<b>APPLICATION FOR PERMIT TO DRILL</b>				5. MINERAL LEASE NO: <b>ML-22794</b>	6. SURFACE: State
1A. TYPE OF WORK:    DRILL <input checked="" type="checkbox"/> REENTER <input type="checkbox"/> DEEPEN <input type="checkbox"/>				7. IF INDIAN, ALLOTTEE OR TRIBE NAME:

2. NAME OF OPERATOR: <b>KERR McGEE OIL &amp; GAS ONSHORE L.P.</b>				9. WELL NAME and NUMBER: <b>STATE 1021-31N</b>	
3. ADDRESS OF OPERATOR: <b>1368 S 1200 E</b> CITY <b>VERNAL</b> STATE <b>UT</b> ZIP <b>84078</b>			PHONE NUMBER: <b>(435) 781-7024</b>		10. FIELD AND POOL, OR WILDCAT: <b>NATURAL BUTTES</b>

STATE 1021-31N  
SE/SW SEC. 31, T10S, R21E  
UINTAH COUNTY, UTAH  
ML-22794

SCALE: 1"=2000' DRAWN BY: B.C. REVISED: 04-13-07C.P.

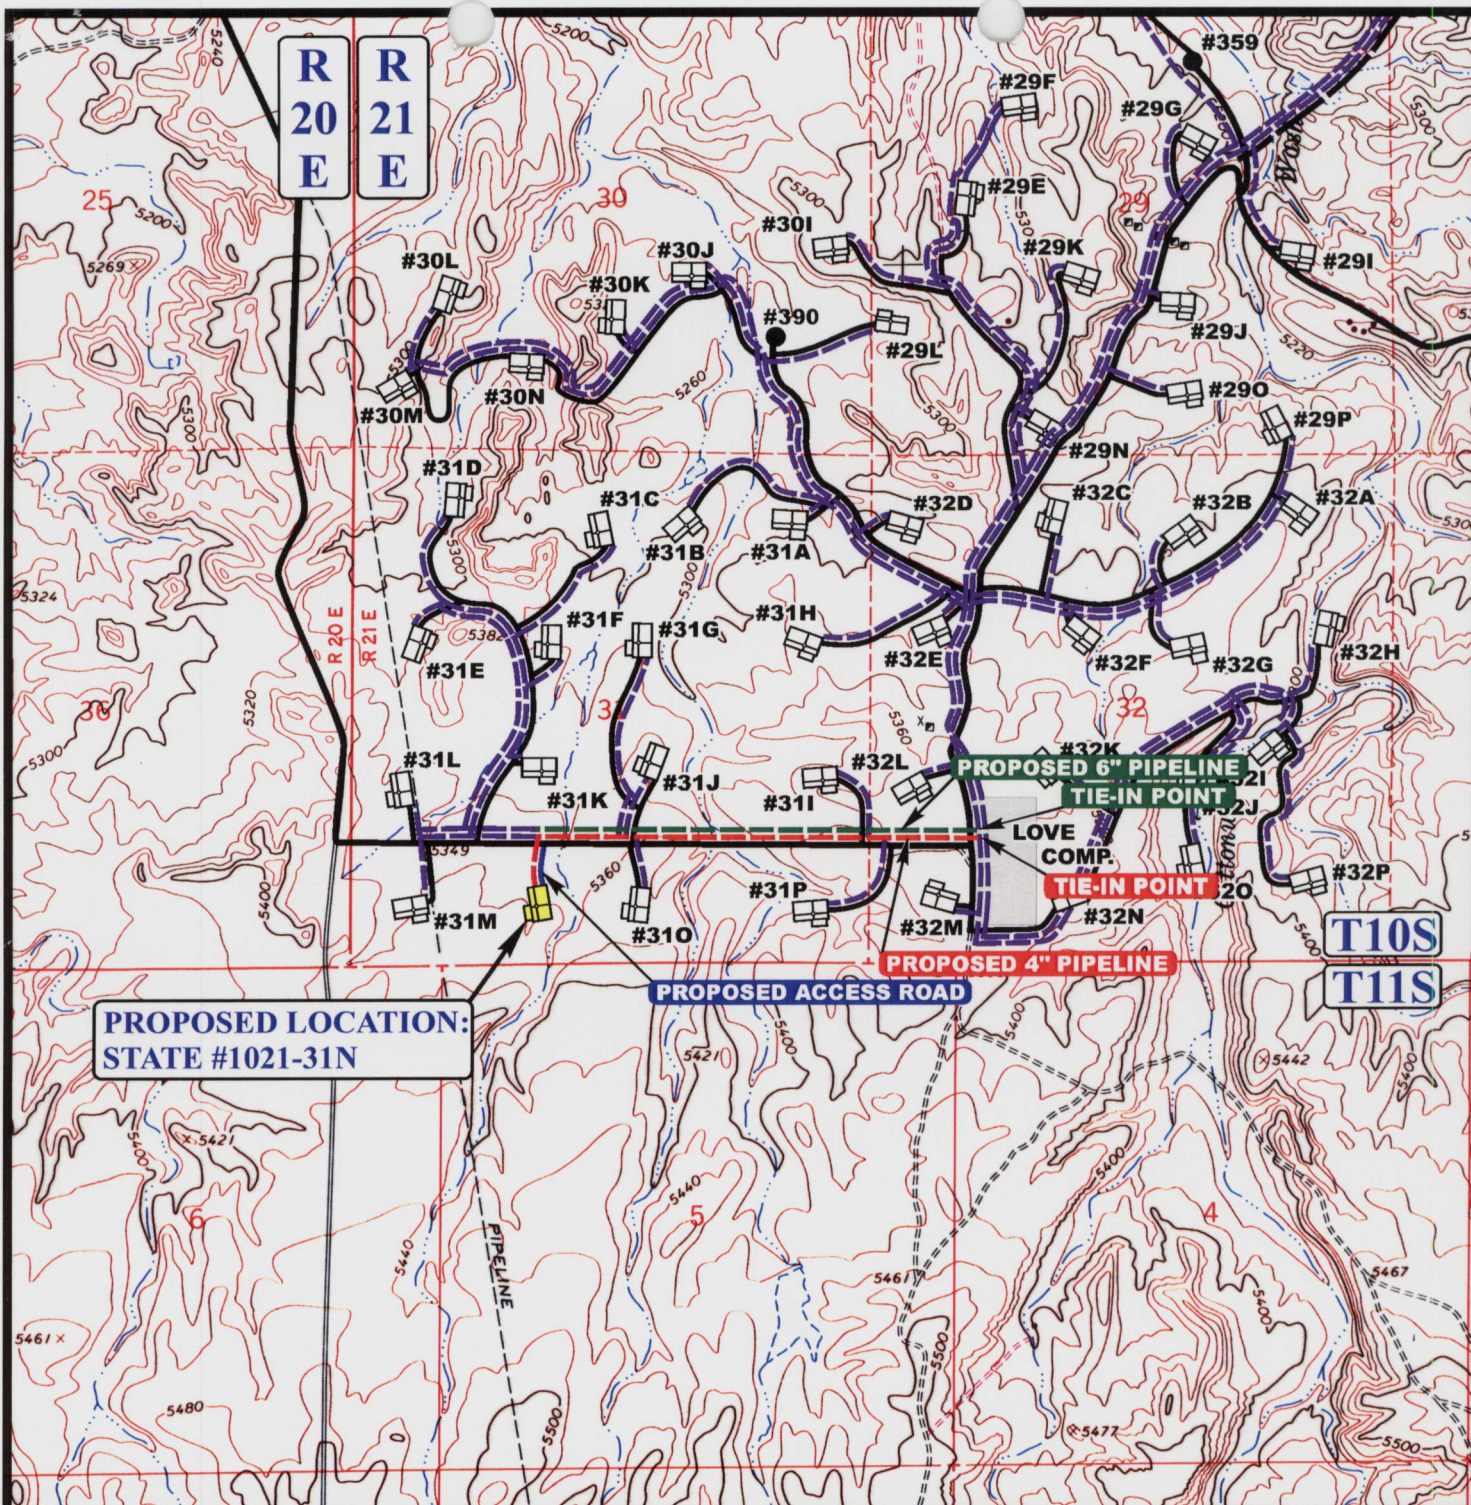
An onsite was conducted on 4/5/07 with the Division of Oil, Gas and Mining Representative and SITLA Representative. It was decided to change the proposed pipeline from a 4" pipeline approximately 486' +/- to a 4" pipeline approximately 5,150' +/-, and a 6" pipeline approximately 4,650' +/-.
